ADDENDUM #2

NOTICE TO ALL BIDDERS FOR
CITY OF WINCHESTER

ITB #202005 – Valley Avenue Improvements

PROJECT	SHEET NO.
U000-138-R04	20(13)

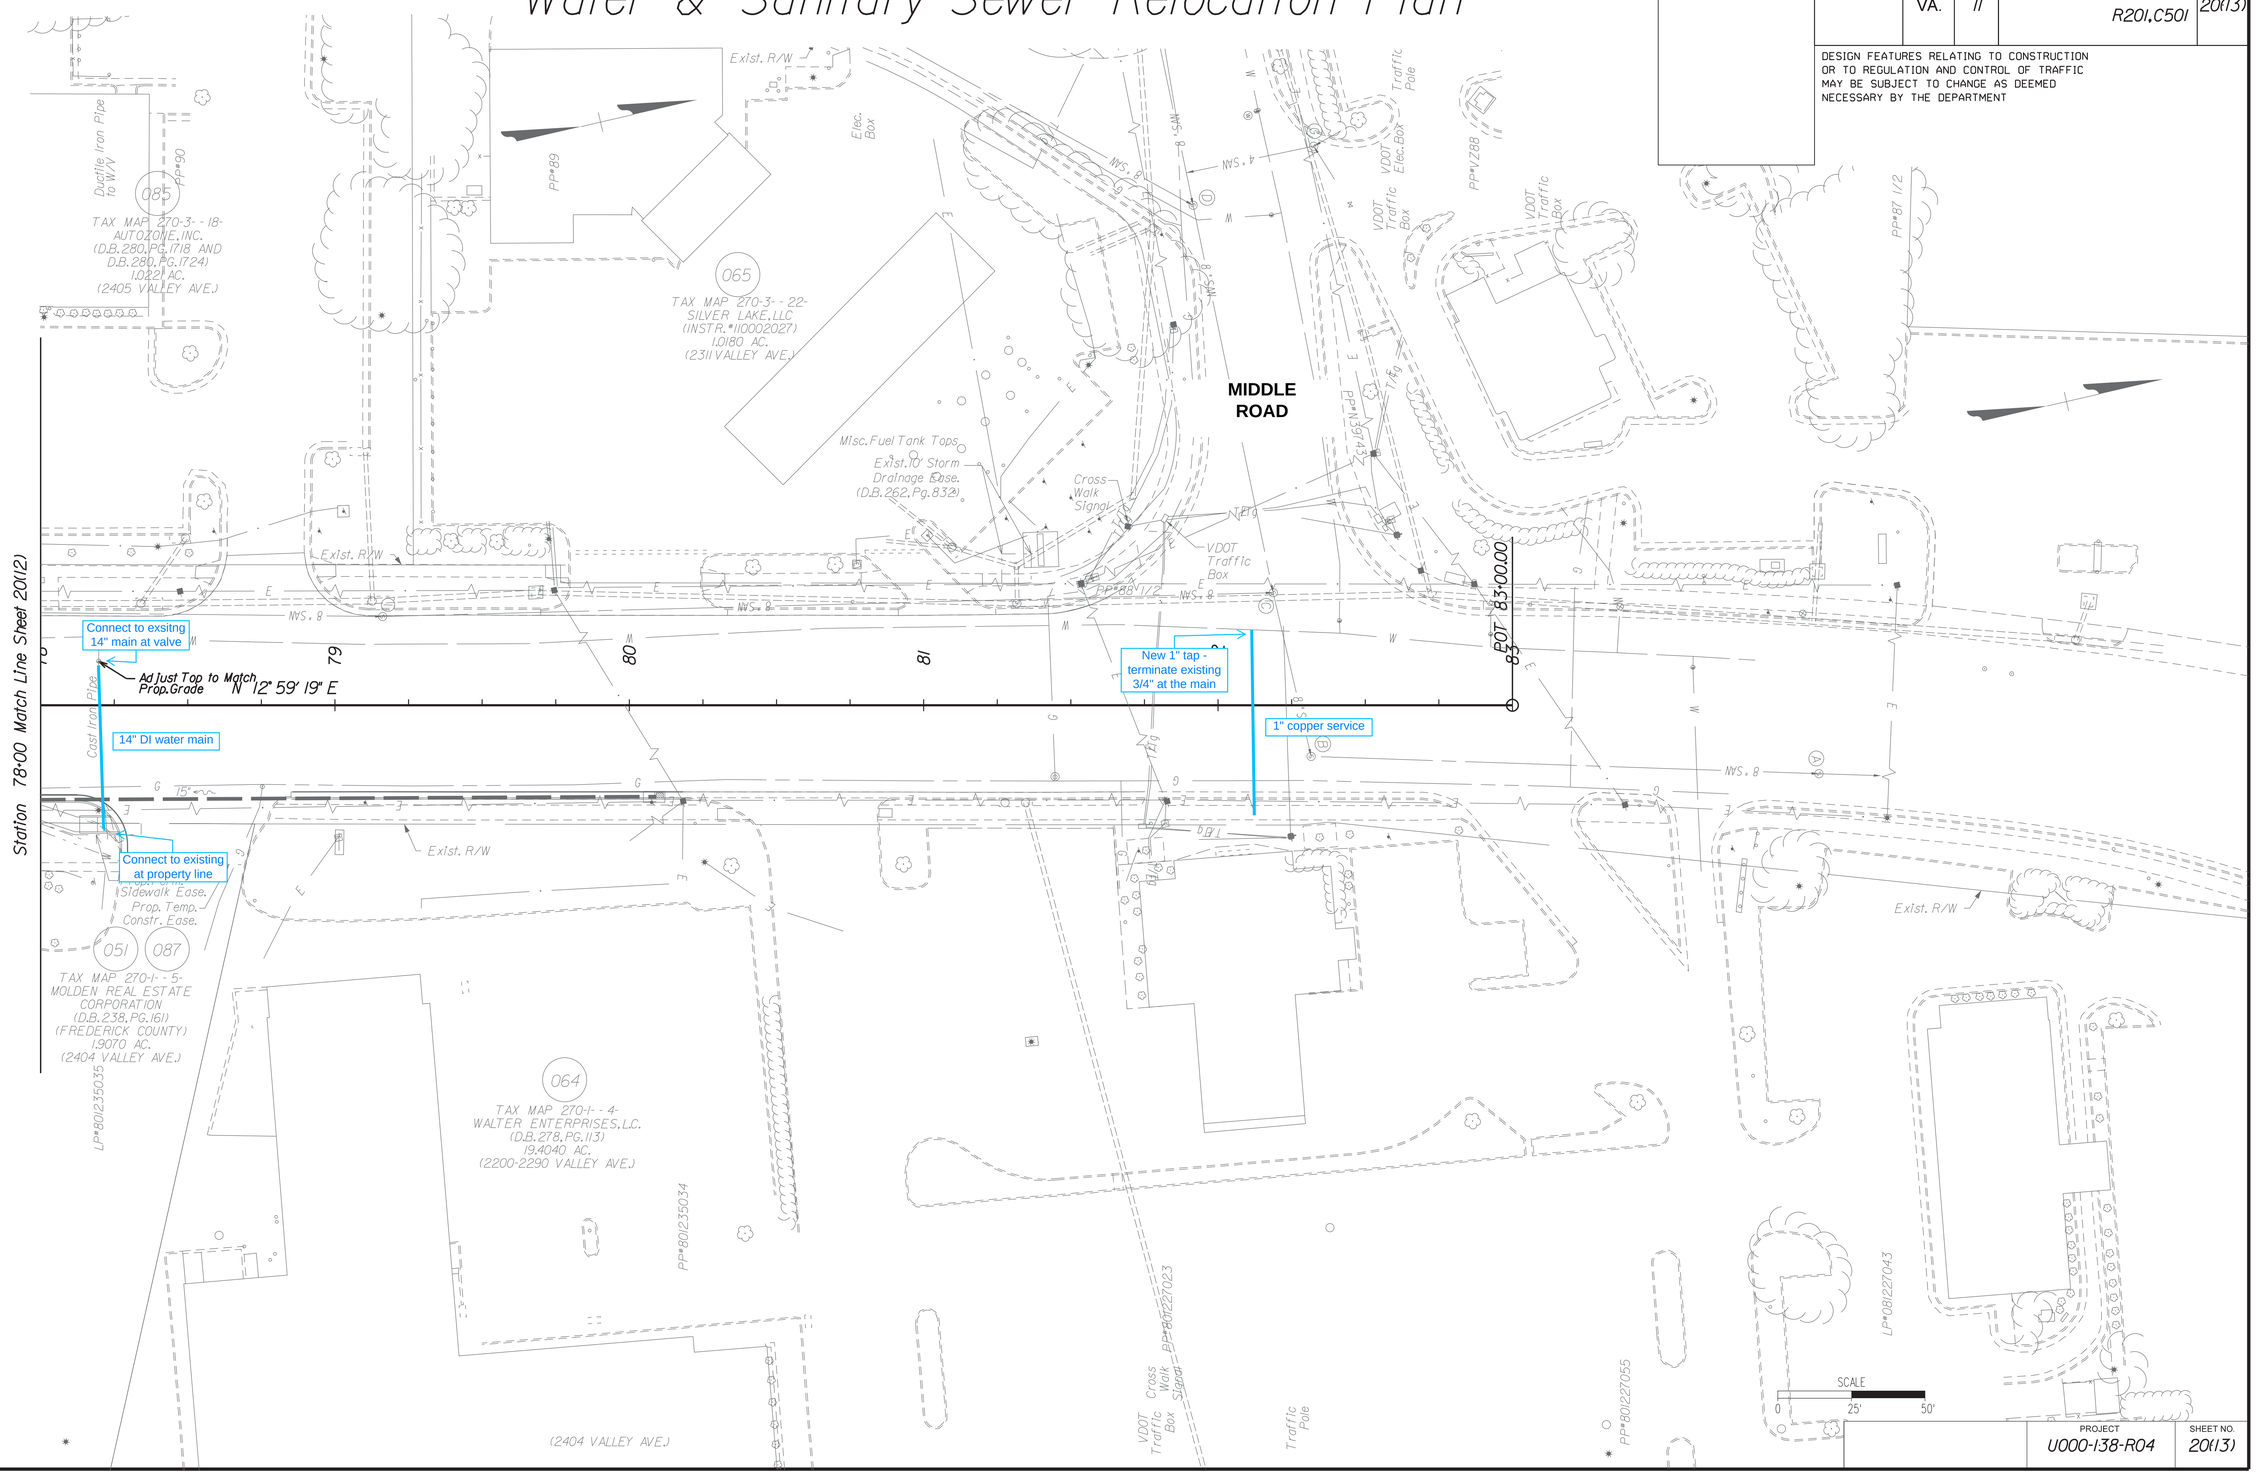
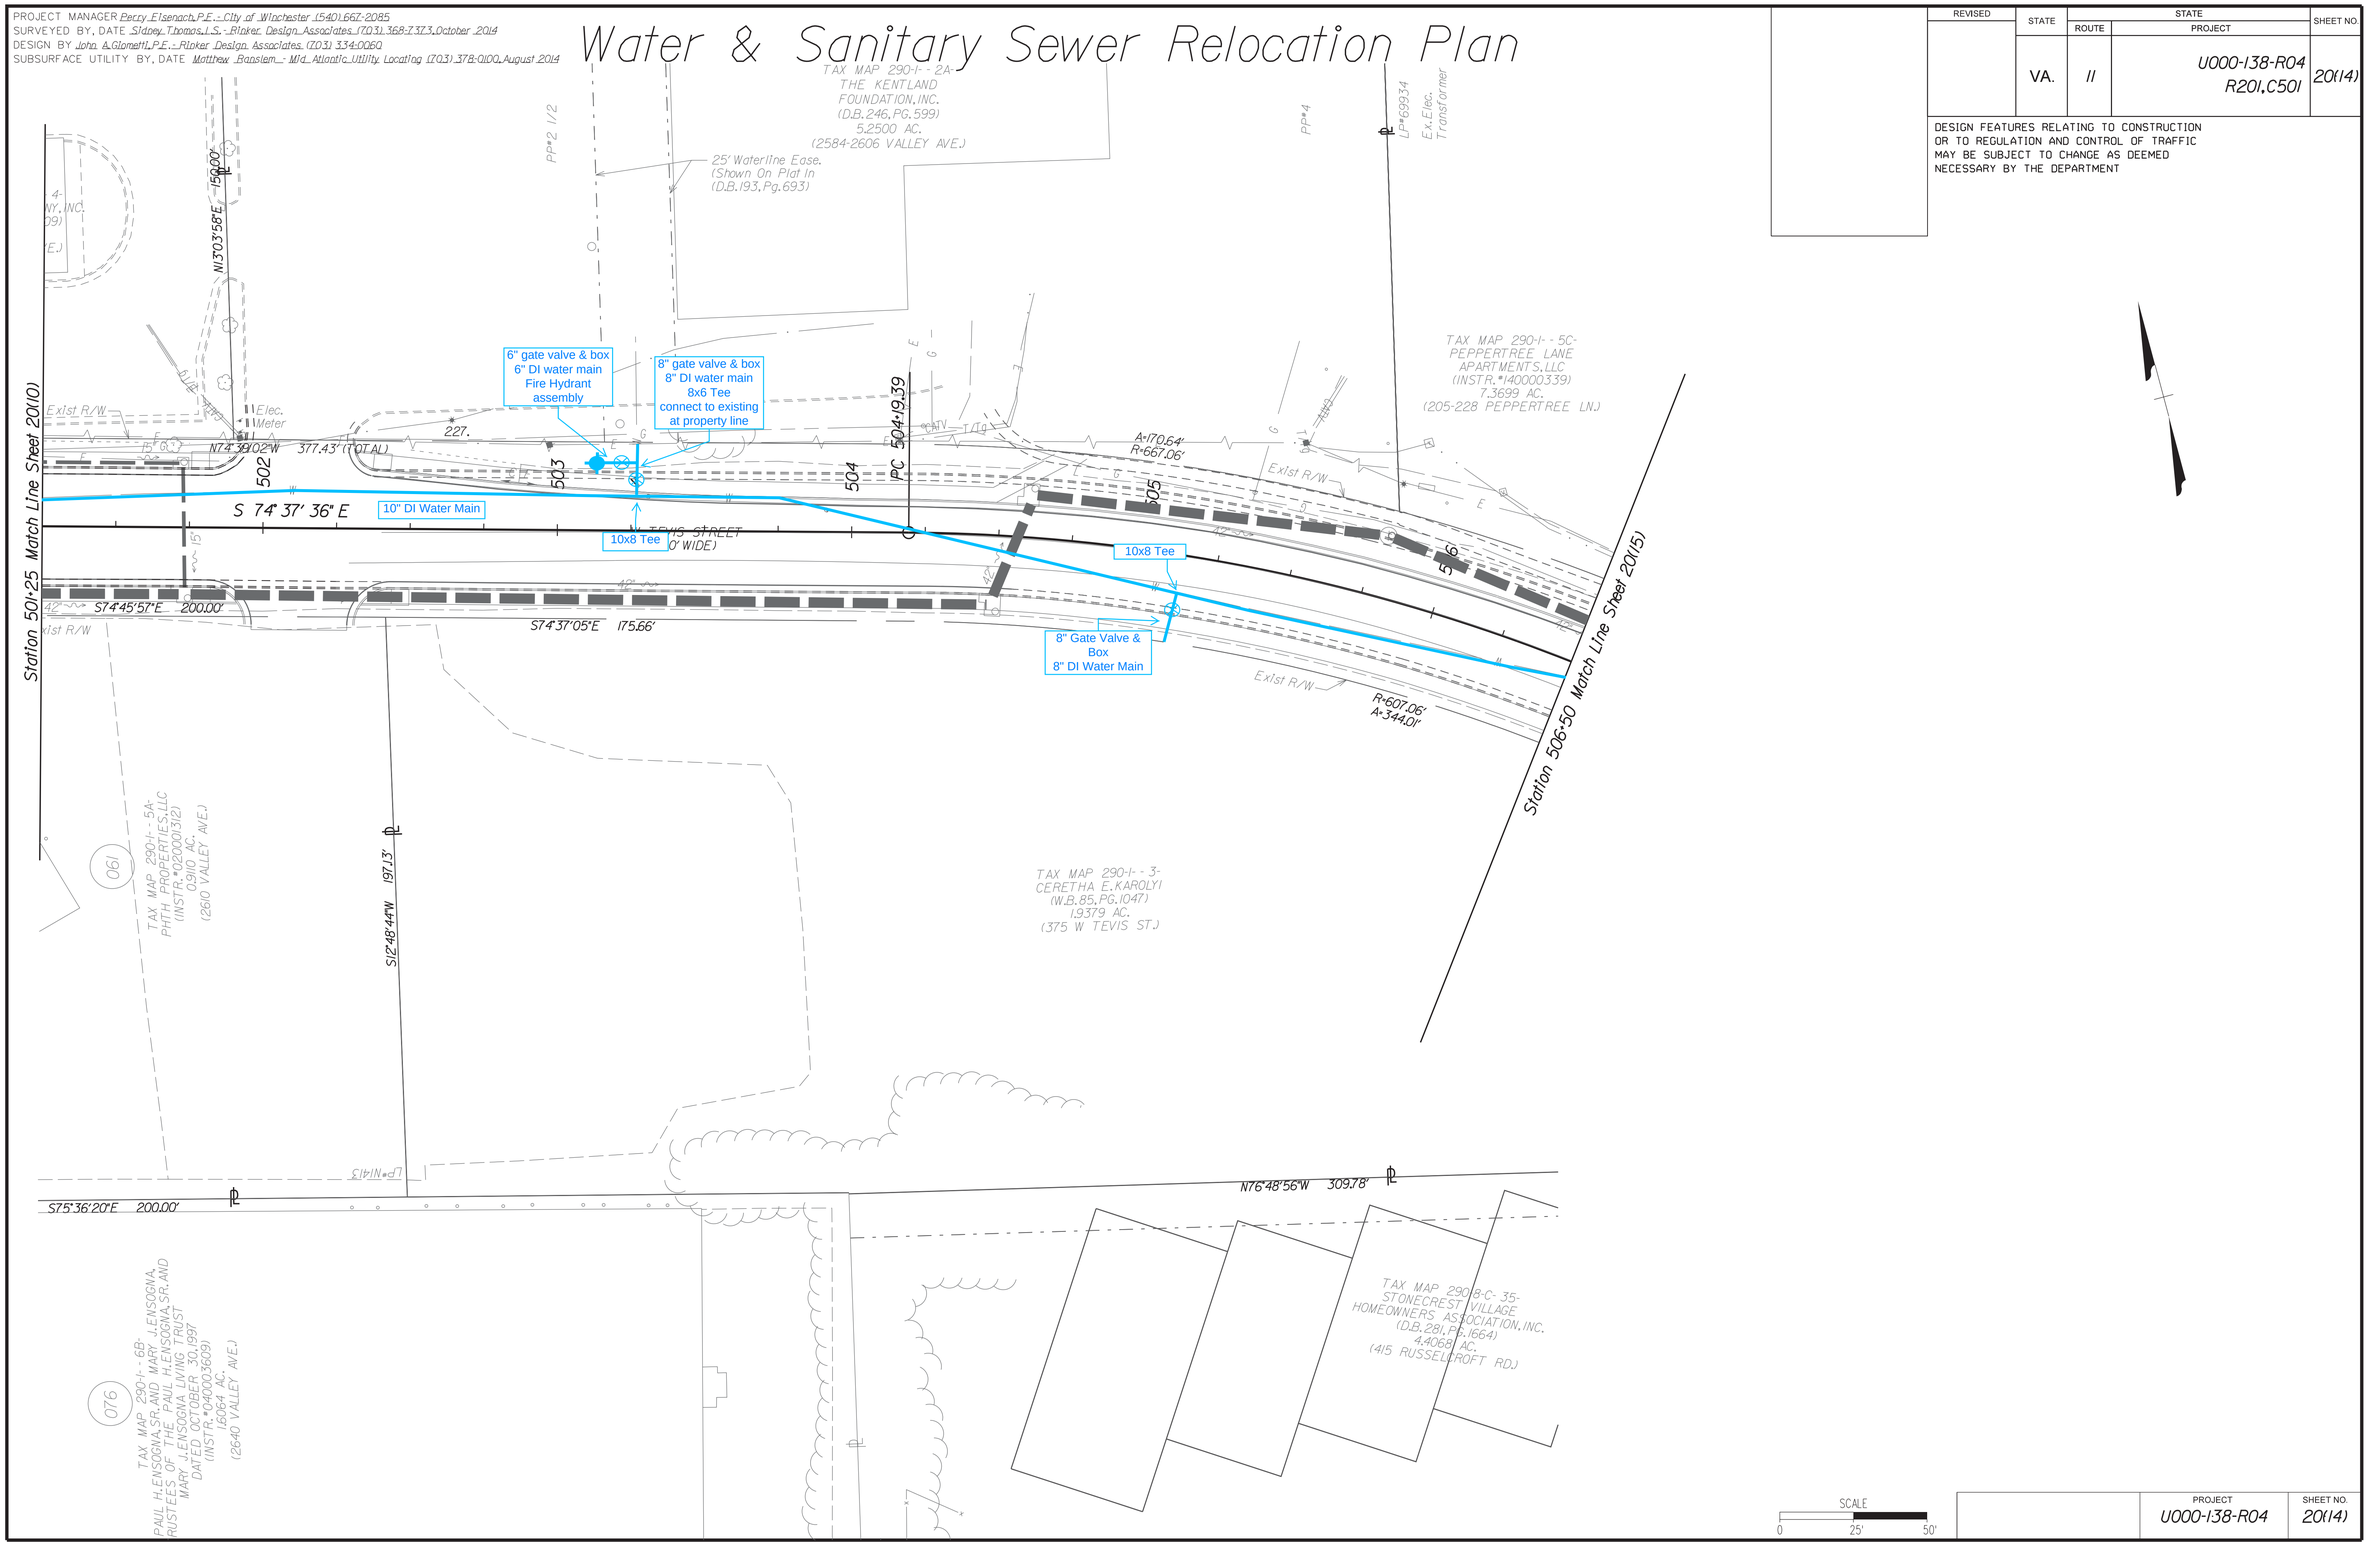
6. There have been numerous additions made to the water and sewer replacements for this project that are included in the revised Bid Form. The original plans have been modified with color showing this information and are attached.
